ADDENDUM NO. 02

January 8, 2026

2026 - Zionsville Community Schools District Wide Improvements
Zionsville, IN 46077

A D D E N D U M N O. 2

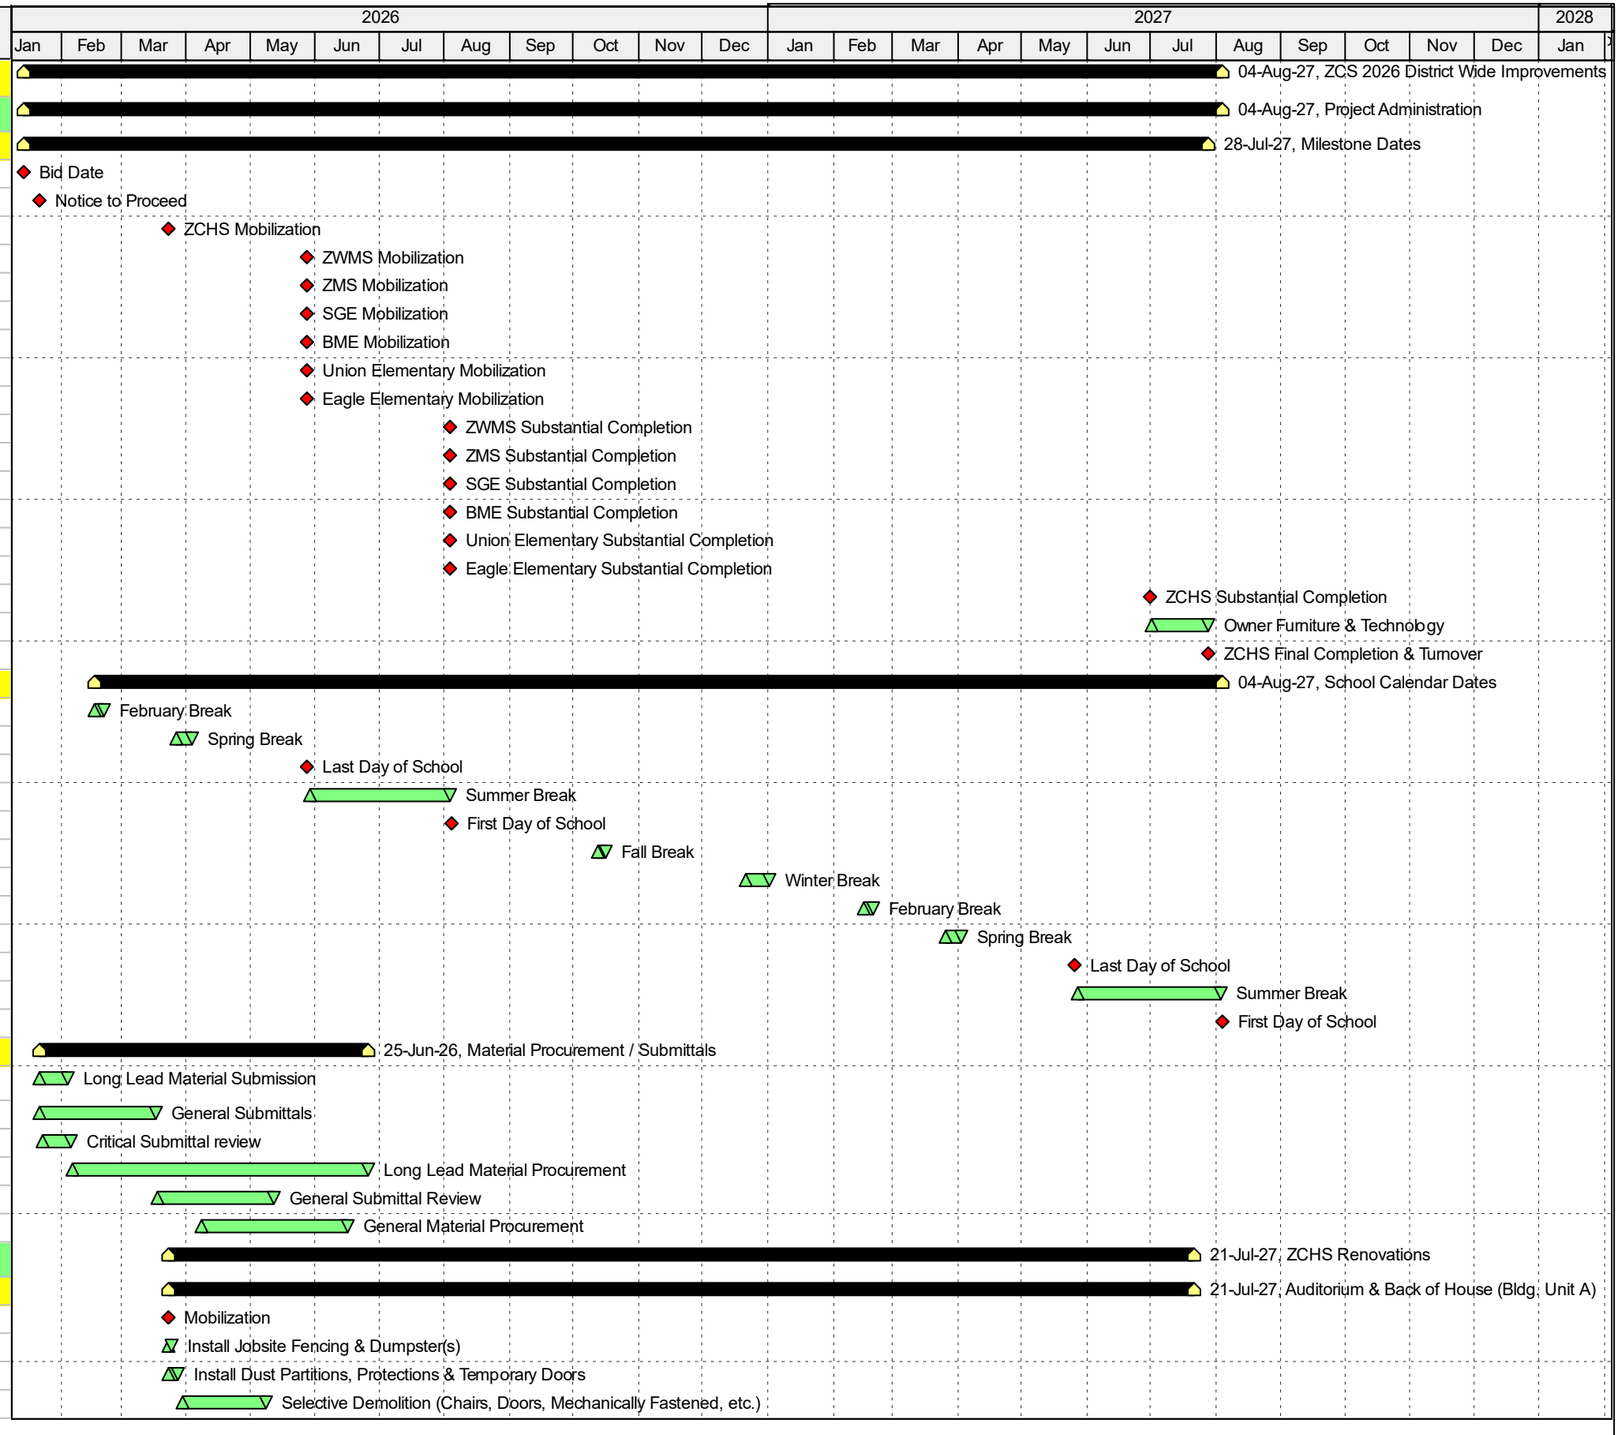
A. Replace general notes – fire alarm as follows:

"12. See sheet ZW-E-001 for fire alarm symbol legend, fire damper detail and spare fire alarm devices as indicated in electrical general notes."
